Chapter 6

**DESIGN W/ NEW PROPOSED STANDARD
(PROTECTIVE SHROUD REMOVED)**

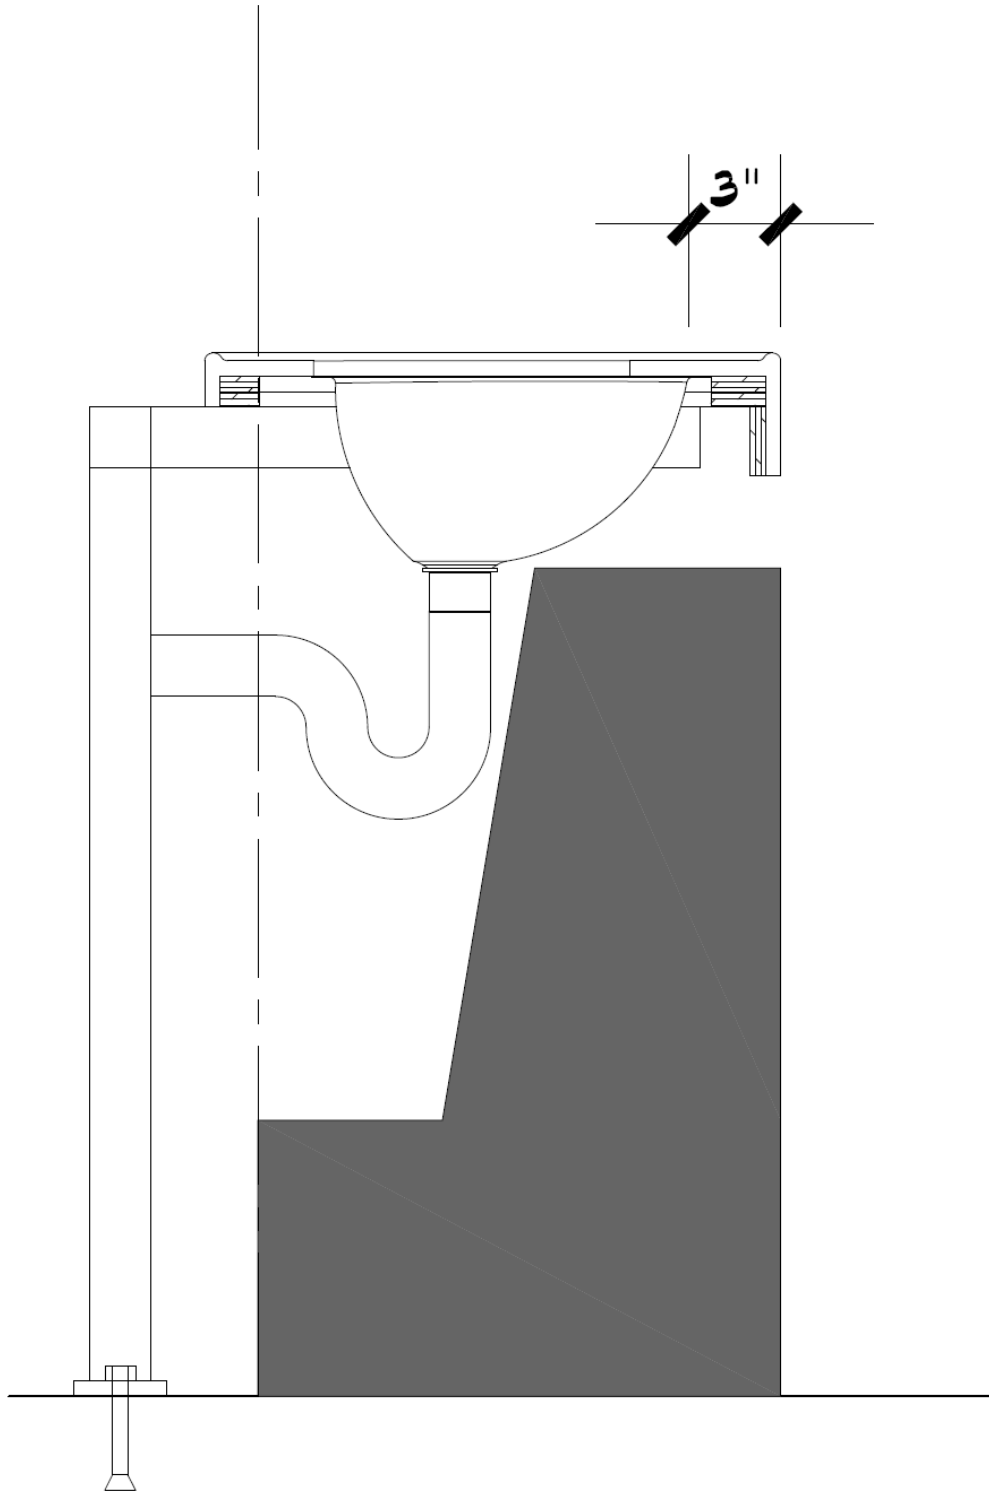
606.5 Basin Location. The interior edge of the rim of the lavatory basin shall be located 3 ½ inches (~~75~~ 90 mm) maximum from the front edge of the fixture or countertop.

Reason: At the current 3" the from the front edge most sinks would not be able to comply with the required knee clearance. It would be impossible to meet the 8" deep requirement.

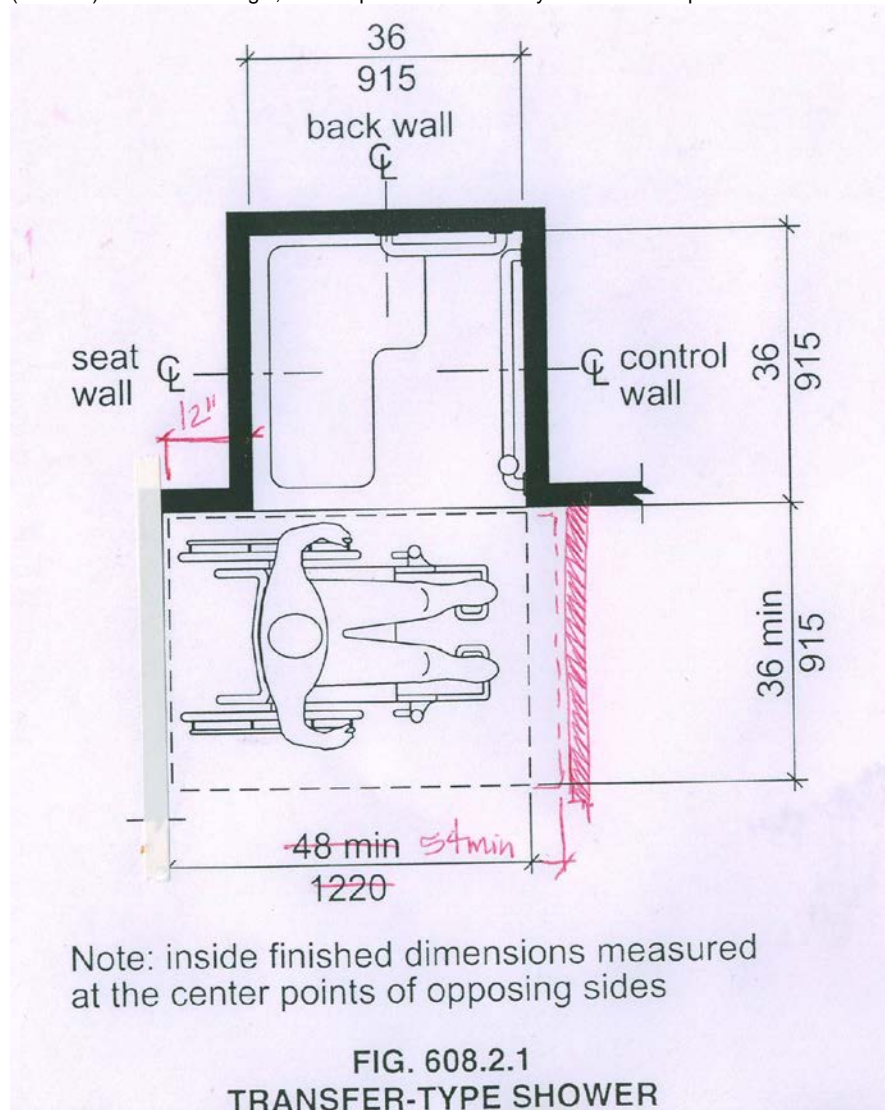
608.2.1.2 Clearance. A clearance of 52 inches (1360 mm) minimum in length measured perpendicular from 42 inches (305 mm) beyond the control seat wall, and 36 inches (915 mm) minimum in depth shall be provided adjacent to the open face of the compartment.

Reason: The increased clear floor space, combined with the change to measure from the seat wall instead of the control wall now prohibits the transfer shower from ever being located in the corner. The shower has to have at least 4" offset (see figure). The study information provided for the increase in clear floor space did not include information on acceptable transfers. The plumbing industry has done these studies. They should be investigated before revising this measurement.

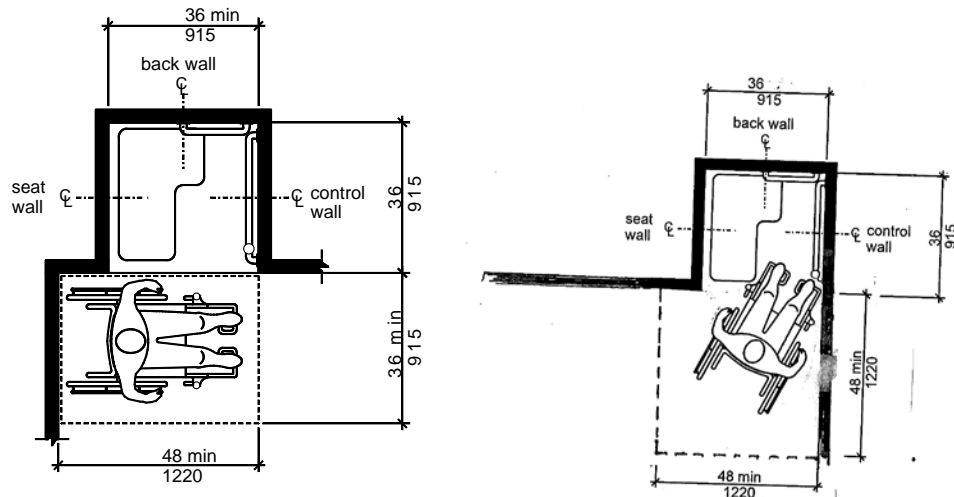
Reason: Delete this figure

The existing figure to accompany this provision should be modified because transfers for individuals who are non-weight bearing or non-ambulatory are not linear transfers. The figure implies a transfer position that is non-functional and impossible for non-weight bearing and non-ambulatory individuals to transfer from. This linear figure should not appear anywhere in the standard. Non-weight bearing and non-ambulatory wheelchair users will position the wheelchair anywhere from a 45 degree angle to a 90 degree angle from the shower seat. They will run the front of the wheelchair (feet) into the shower as far as possible and plant their feet and pivot in an arc to the shower seat. Additional floor space beyond the control wall is useless and unnecessary for this type of transfer. To accommodate the larger clear floor space of the wheelchair, additional depth of the clearance is required. This arc type transfer is similar for transferring to any object, water closet, bench, etc.
